PHAP16-00004

Date: April 18, 2016
Application Type: Certificate of Appropriateness
Property Owner: Gus and Flora Sambrano
Representative: El Paso Water Utilities
Legal Description: 33 Manhattan Heights 8 to 10, City of El Paso, El Paso County, Texas
Historic District: Manhattan Heights
Location: 1500 Elm Street
Representative District: #2
Existing Zoning: R-3/H (Residential/Historic)
Year Built: 1918
Historic Status: Contributing
Request: Reconsideration of changes to an approved Certificate of Appropriateness for the paving of the parkways after-the-fact
Application Filed: 4/13/2016
45 Day Expiration: 5/28/2016

ITEM #2

Reconsideration of changes to an approved Certificate of Appropriateness for the paving of the parkways after-the-fact

1500 ELM STREET PROPOSED PARKWAY LANDSCAPE PLAN

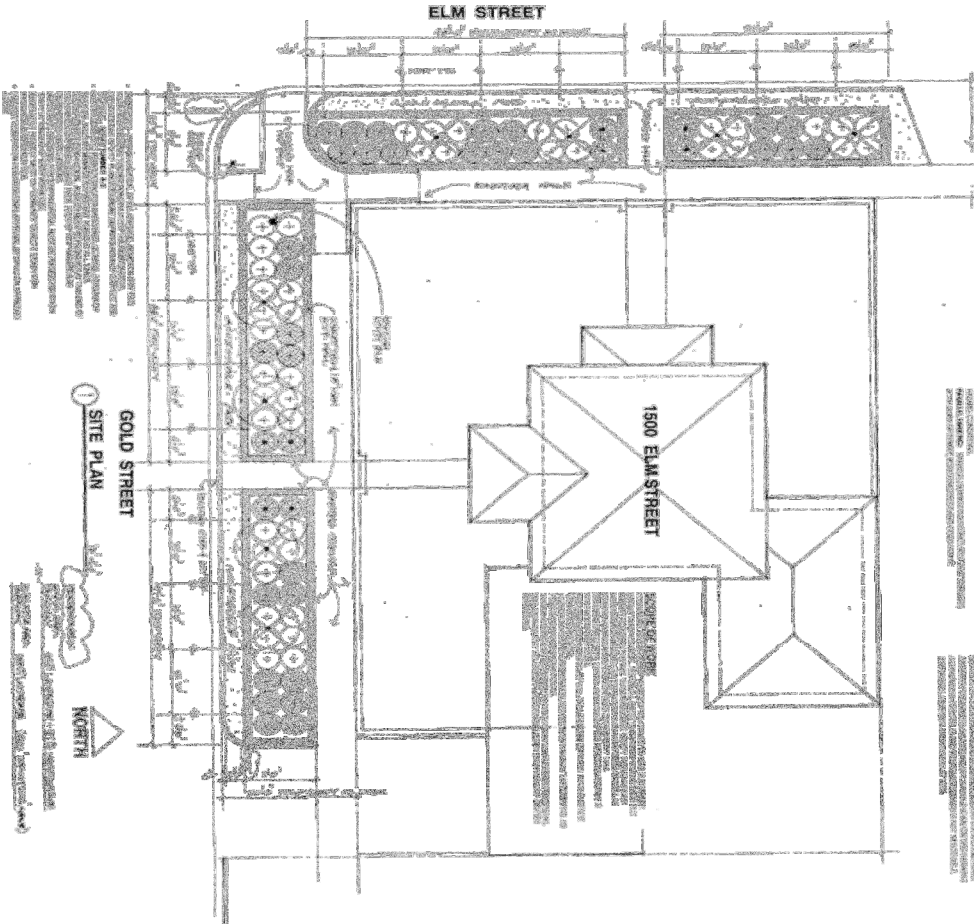
The modification is that the height of the rock wall shall be reduced to less than six inches so that the parkways can absorb water.
